MEMORANDUM

SUBJECT: *Rockville's Pike: Envision a Great Place* – Work Session #12
Form Code standards - continued

Table 1.2.3.A: South Pike Urban Corridor Street Frontage

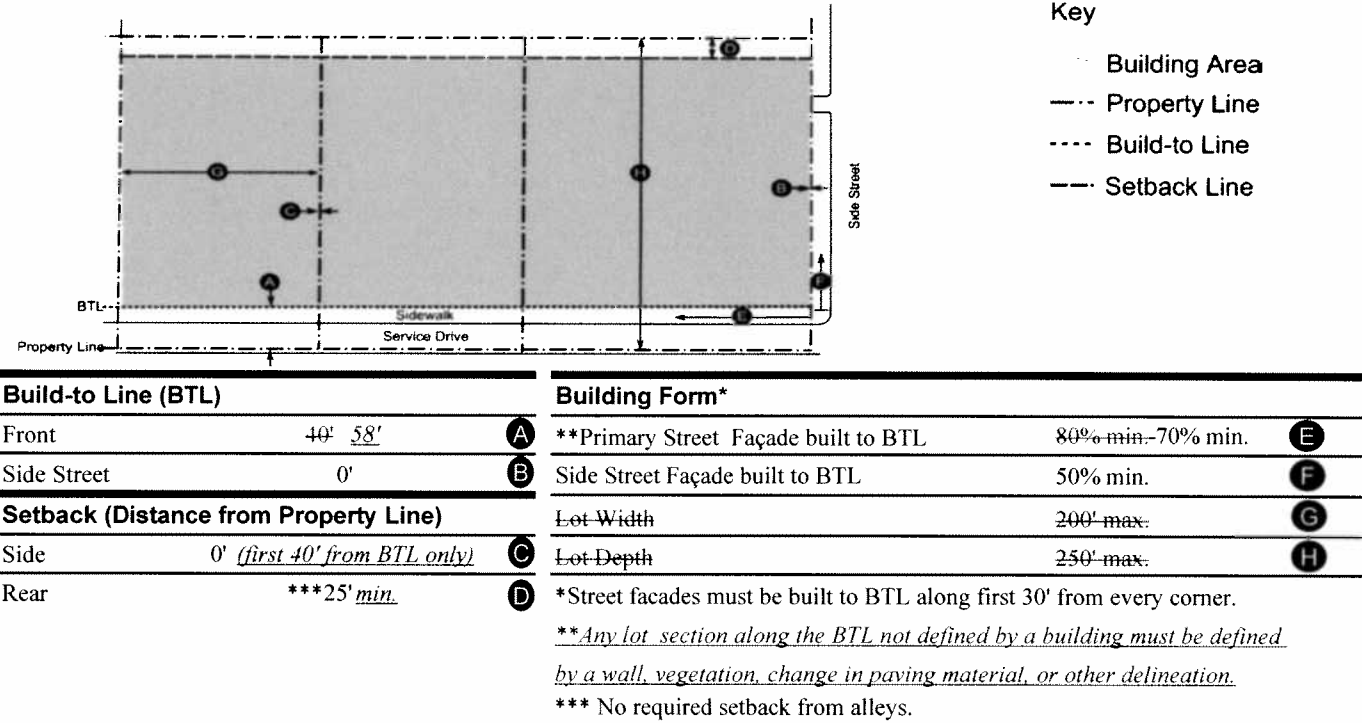
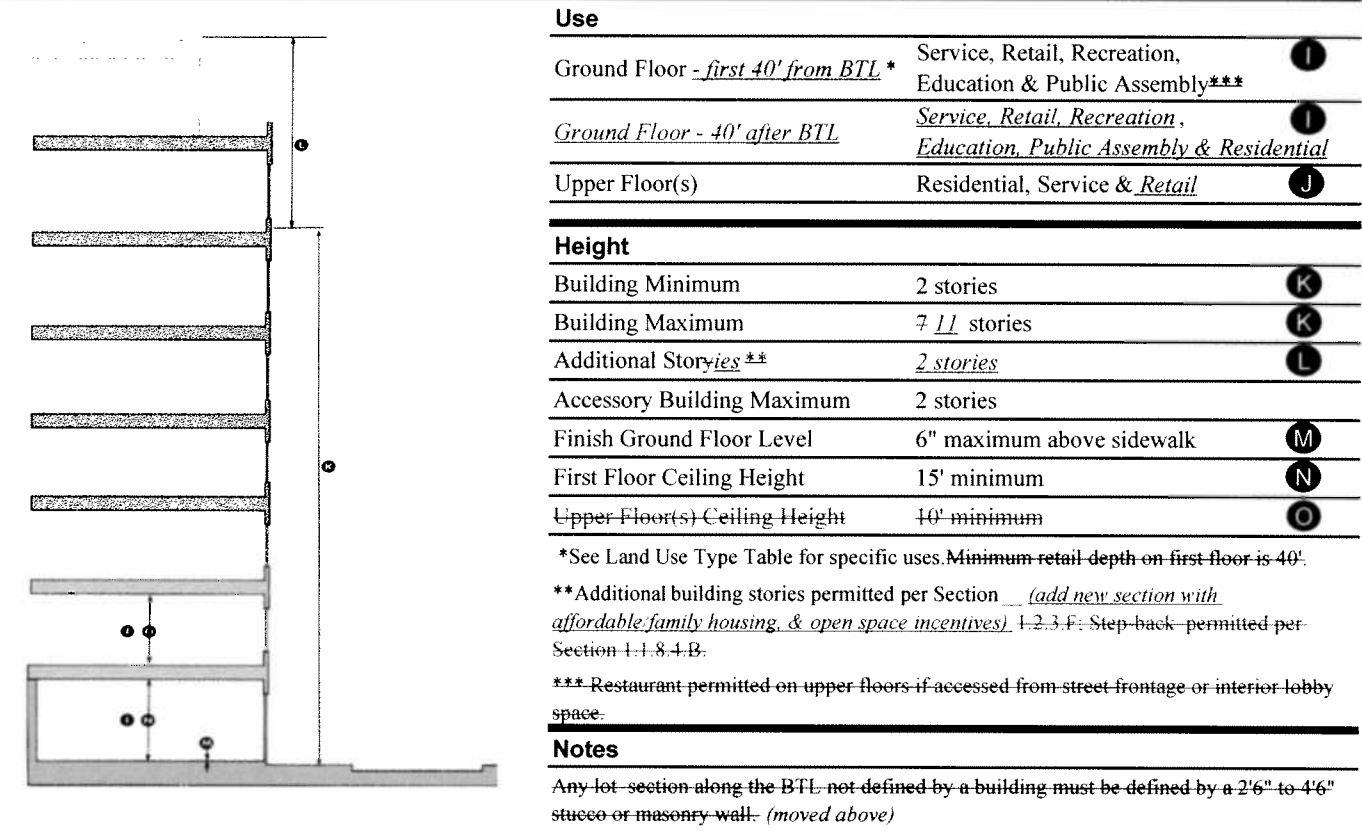
Building Placement (page 28, top half of page)

A graphic is provided at the top of page 28 to guide building placement. The build-to line² facing Rockville Pike is set back 40 feet from the property line. In the draft plan cross section, this 40-foot area contains the access road, on-street parking, sidewalk, and landscaped median that separates the through lanes from the local access lanes. The property line in this case begins 60 feet from the center line of Rockville Pike because of the State’s 120 feet of right-of-way. As a result, the build-to line would be a total of 100’ from the center line of Rockville Pike (resulting in an overall recommended 200’ from building face to building face on the Pike). The 1989 plan placed the build-to line for the Pike at 135’ from the center line, resulting in 270’ from building face to building face.

A 25-foot rear setback is required unless there is an alley present, in which case no rear setback is required from the alley. There is no setback from the property line on side streets, meaning that buildings are to be built right up to the sidewalk.

There is another type of “side” setback presented in the code: the amount of distance that one building may be from another, across a property line. The draft recommends that buildings be immediately adjacent to each other on the Pike, resulting in the zero-foot setback in the code for this frontage.

While staff supports a zero setback within each block on the South Pike corridor facing the Pike, staff believes that more flexibility is warranted behind the street front. Staff recommends that this zero side setback only extend 40 feet back from the front build-to line so that there is continuous building at the sidewalk, but areas for open space could be allowed between buildings toward the rear. If a side setback were to be created between lots, the setback would need to meet the City’s building code requirements for separation of buildings.

At least 80% of the building façade fronting the “primary street” must be built at the build-to line under the form code. The consultants have stated that a primary street is intended to be the street that a building’s main entrance faces.³ This compares to the 50% build-to line requirement in the 1989 Pike Plan and the 70% build-to line requirement in the zoning ordinance for mixed use zones where a build-to line is established by the plan. The form code’s build-to line at a side street is a minimum of 50%.

The draft code includes a notation that any lot section along the build-to line not defined by a building must be defined by a 2’6” to 4’6” stucco or masonry wall. Staff recommends that this note be amended to allow for other delineations besides a wall, such as shrubbery or a change in paving material.

Height and Use (page 28, bottom)

A diagram of building and ceiling heights is provided at the left side of page 28. The form code regulates building height by maximum number of stories rather than by feet. Measuring by stories is more likely to result in greater variation because ceiling heights, interstitial space between floors, and roof forms will be different among buildings.

- The front build-to line will be adjusted based on the Pike cross-section(s) selected. Alternatives 2 and 9, tentatively selected by the Commission, would move the build-to line to 58 feet from the property line, as compared to 40 feet in the draft plan.

- At least 70% of the building façade fronting the “primary street” (the Pike is the primary street for this frontage) should be built at the build-to line, as compared to 80% recommended in the draft plan. (See section II below for staff's recommendation on how this might be calculated).

- Any lot section along the primary street build-to line not defined by a building must be defined by some demarcation, which could include a wall, vegetation, a change in paving material, or other delineating material. (The draft plan requires that it be a 2.5-foot to 4.5-foot stucco or masonry wall).

- The side street build-to line is 0 feet, which is at the sidewalk on side streets.
- At least 50% of a building façade on a side street should be built at the build-to line.

- The 0-foot side setback (between buildings on a block) should only extend 40 feet back from the front build-to line so that there is continuous building at the sidewalk along the Pike, subject to the 70% build-to requirement, but areas for open space could be allowed between buildings toward the rear. If a side setback were to be created between lots, the setback would need to meet the City's building code requirements for separation of buildings.

Table 1.2.3.A: South Pike Urban Corridor Street Frontage

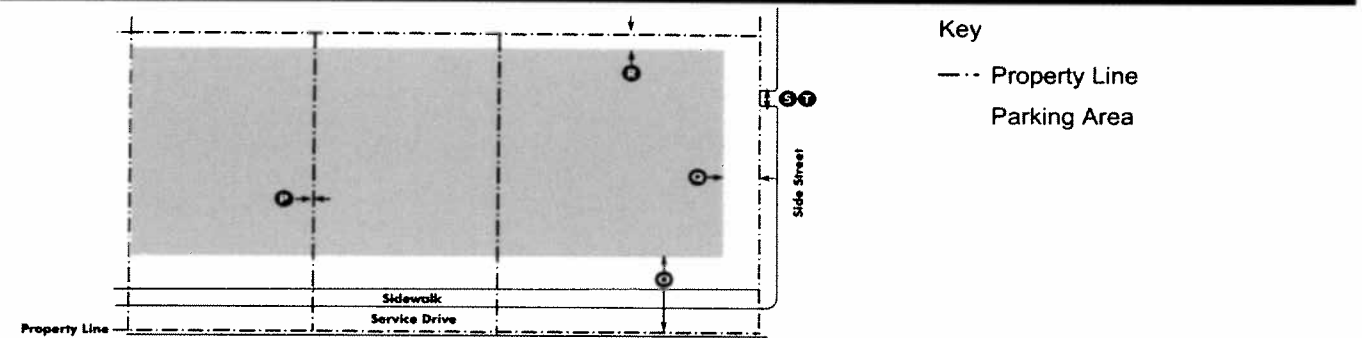
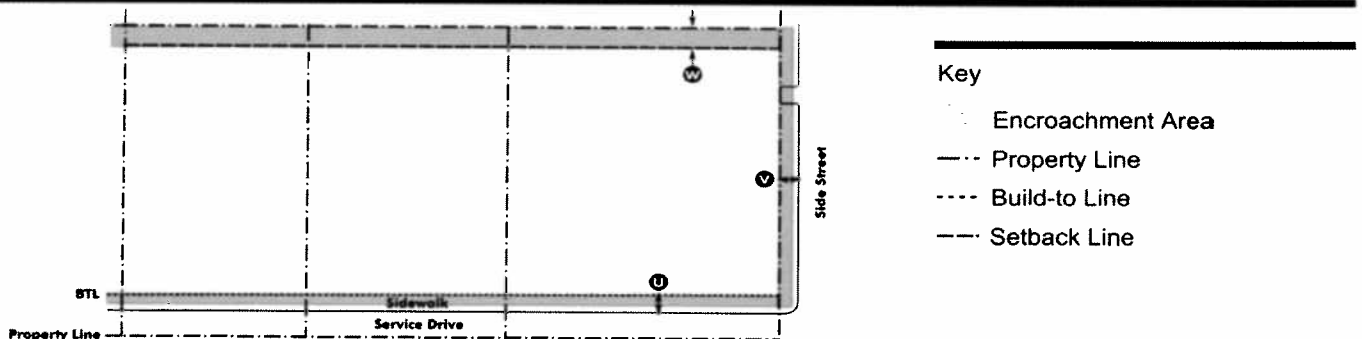
Parking (page 29, top)

The allowable parking area is illustrated by the diagram at the top of page 29. Parking is set further back than the building at the front and side streets, but the rear setback is 5 feet. As with the building placement, the front setback would need to be adjusted if the boulevard cross section is changed.

Staff recommends measuring the parking front setback from the build-to line instead of the property line because the parking should be defined in relation to the building rather than ownership lines. Staff further recommends that all of the parking setback standards be minimums instead of exact standards, and that underground parking not be subject to setbacks, but be allowed to be located up to the property line.

Encroachments (page 29, bottom)

Staff recommends adding two notes to this section. The first is that encroachments over utility easements shall be constructed to be easily removable or maintain a clear height of a to-be-determined number of feet. The second recommended note states that encroachments that exceed a width of more than 20% of the linear building façade at the build-to line require approval from the appropriate approving authority.
